# Wisconsin Department of Transportation

**Proposal #49: 7130-01-72, WISC 2016 189**  
**C Arcadia, STH 93**  
**Detloff Drive to STH 95**  
**STH 93**  
**Trempealeau County**

**7130-01-74, WISC 2016 190**  
**Centerville - Independence**  
**0.8 Miles North Junction CTH G**  
**STH 93**  
**Trempealeau County**

This is Addendum No. 01, which provides for the following:

Addendum No. 01  
 ID 7130-01-74  
 Revised Sheet 3  
 May 5, 2016

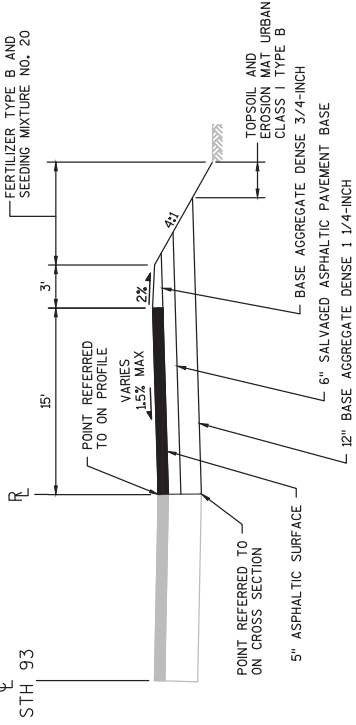
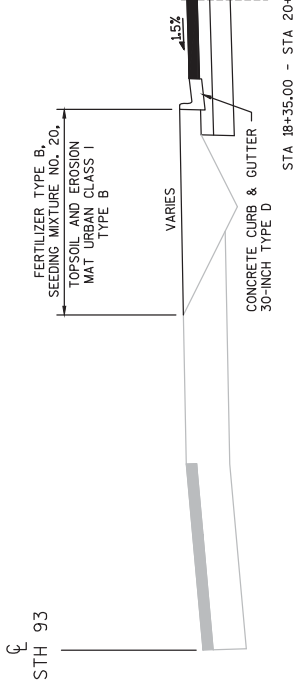
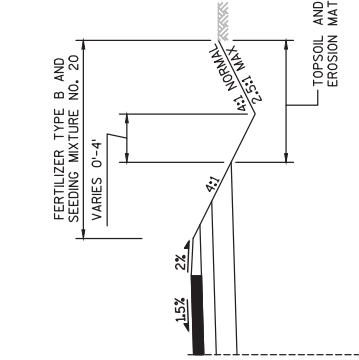
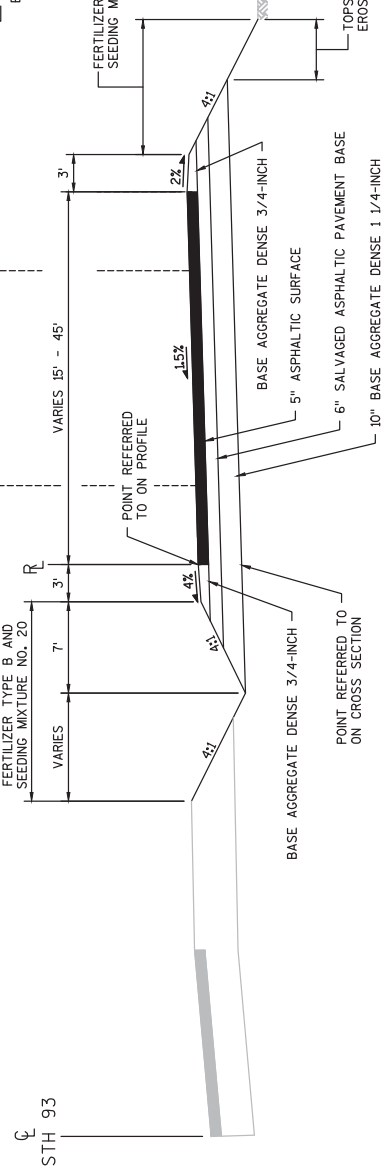
Revised Plan Sheets – ID 7130-01-74	
Plan Sheet	Plan Sheet Title (brief description of changes to sheet)
2	General Notes
3 – 4	Typical Sections (Sheets were blank in plan)
38	Earthwork
39 – 47	Cross Sections (Sheets were blank in plan)
